ECE/TRANS/WP.29/GRSG/2009/8
23 February 2009

REGULATION No. 43

(Safety glazing)

Proposal for draft amendments to Regulation No. 43

"Rigid plastic windscreens

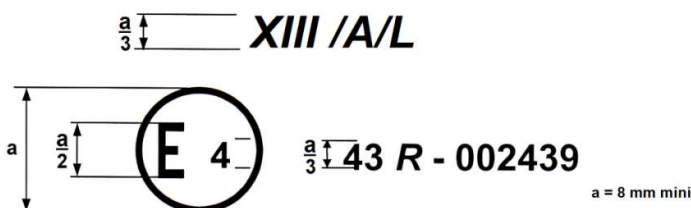
The above approval mark affixed to a rigid plastic windscreen shows that the component concerned has been approved in the Netherlands (E 4) pursuant to Regulation No. 43 under approval No. 002439. The approval number indicates that the approval was granted in accordance with the requirements of Regulation No. 43.

Laminated rigid plastic panes other than windscreens

The above approval mark affixed to a laminated rigid plastic glazing pane for forward facing panels with a light scatter not exceeding 2 per cent after 1000 cycles on the outer surface and 4 per cent after 100 cycles on the inner surface shows that the component concerned has been approved in the Netherlands (E 4) pursuant to Regulation No. 43 under approval No. 002439. The approval number indicates that the approval was granted in accordance with the requirements of Regulation No. 43."
